RE: **Lot 10 Block 5 Volcano Cliffs Unit 8 SAD 227**
8031 Monte Carlo Dr. NW
Grading and Drainage Plan
Engineers Stamp Date 11/17/2021 (E10D108)
Pad Certification Date 5/11/2022

DRAINAGE AND TRANSPORTATION INFORMATION SHEET (REV 6/2018)

ENGINEER'S SEAL	Lot 10 Un 8 Blk 5 VC 8031 MONTE CARLO DR. GRADING AND DRAINAGE PLAN	DRAWN BY DEM
		DATE 10-19-21
10/19/21		Lot 10 Un 8 Blk 5 VC REVISED DWG
DAVID SOULE P.E. #14522		SHEET # C1
	RIO GRANDE ENGINEERING P.O. BOX 53924 ALBUQUERQUE, NM 87199 (505) 321-8099	JOB #

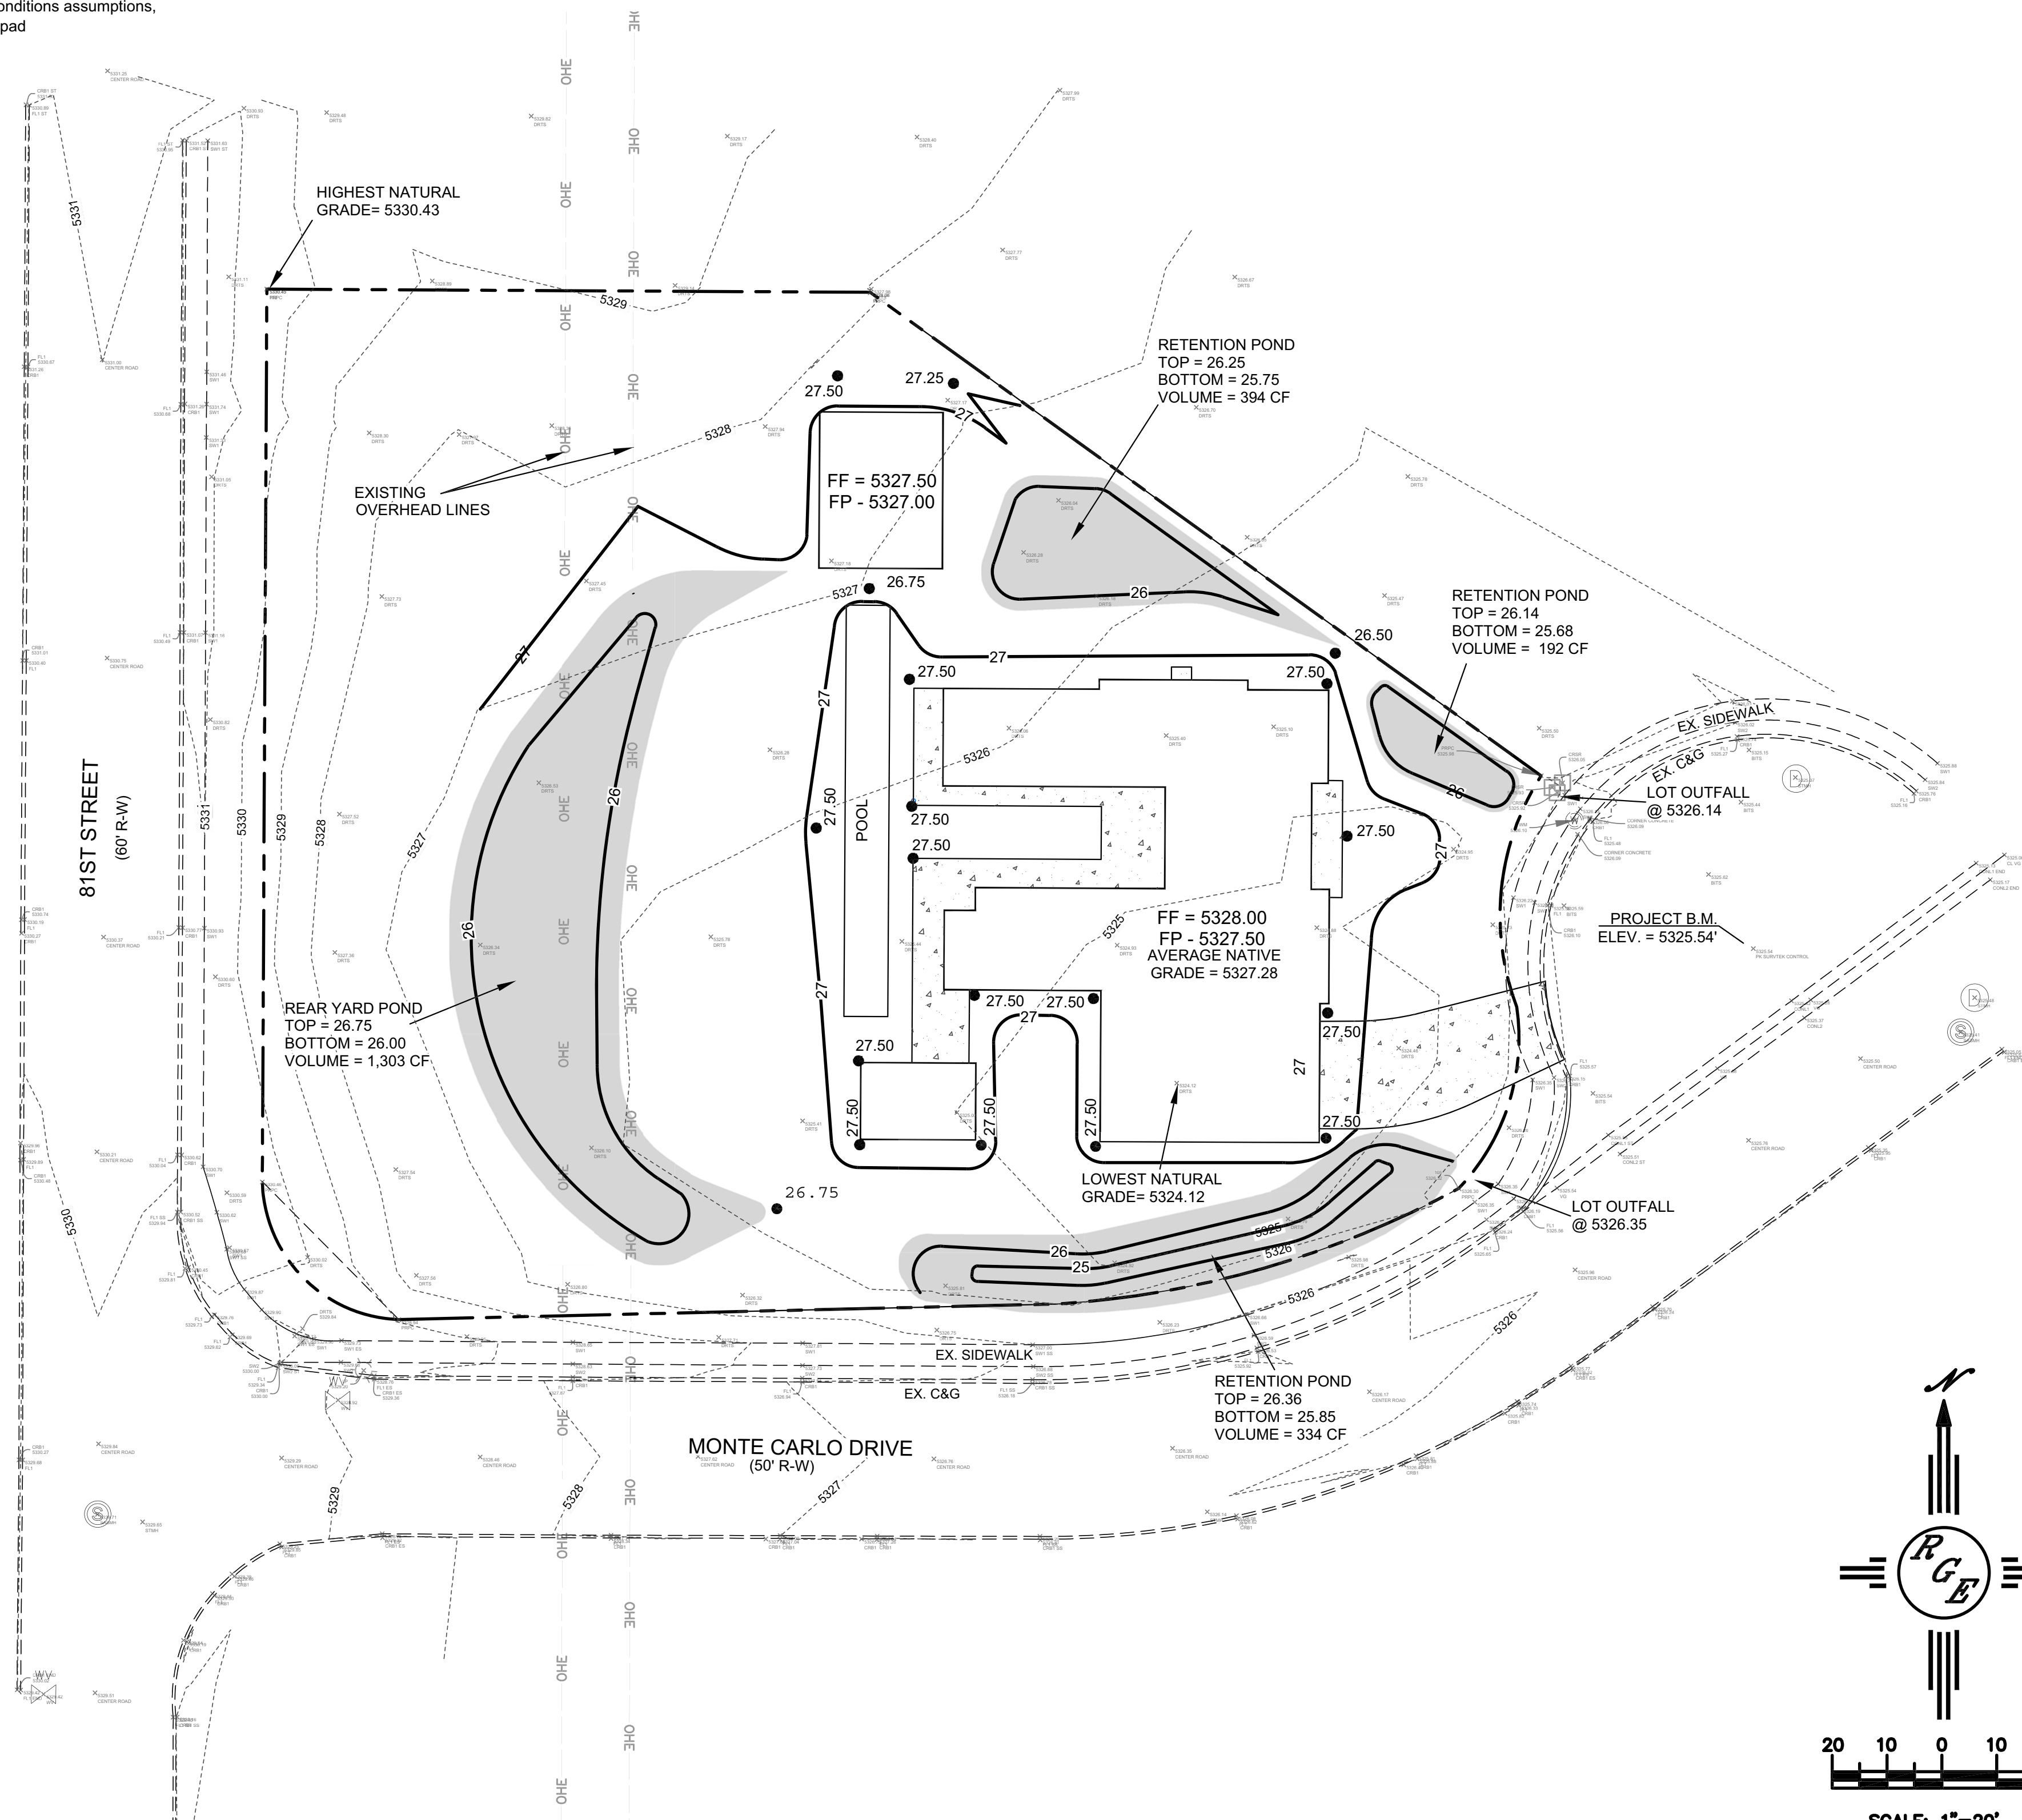
Based upon the information provided in your submittal received 5/11/2022, this plan is approved for Building Permit.

Reiterate to the Owner/Contractor that a separate permit for a garden/retaining wall must be obtained, with the approved G&D plan and Pad Certification. Also, let the owner/contractor know that if a pool is to be added in the future the G&D plan will need to be modified showing the location of the pool and the land treatment differences. Also advise the owner & Contractor that dirt is not allowed in the public right of way to climb the curb. Crusher fines or lumber is allowed. If dirt is used this will delay going forward with the construction of the home.

Prior to Certificate of Occupancy release, Engineer Certification per the DPM checklist of this plan will be required.
